PRE - APPLICATION ADVICE - SEPT 2011

From: Wito, Alan [mailto:Alan.Wito@Camden.gov.uk]
Sent: 30 September 2011 18:04
To: ted.walters@blueyonder.co.uk
Subject: **Pre application advise for 40 New End Square (ref CA\2011\ENQ\05200)**

RE Application Ref 2011/5217/L

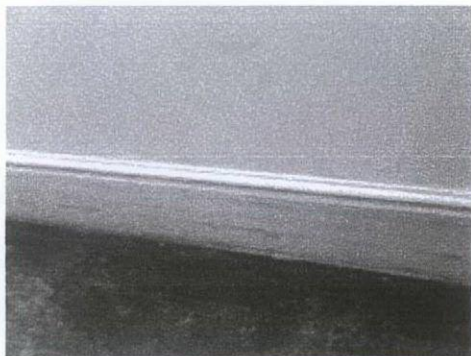
e) The t and g flooring and Taurus skirting boards throughout the ground floor were installed in the 1970s and are of no historic value (see photos)

The pine floor boarding to the 1st floor is of historic value so the new floor will be fitted onto packing timbers approx 20 - 80 mm above (see photos)

New item) The breeze block wall at the head of the basement staircase installed in the 1970s is of no historic value and can be removed to BC approval (see photo)
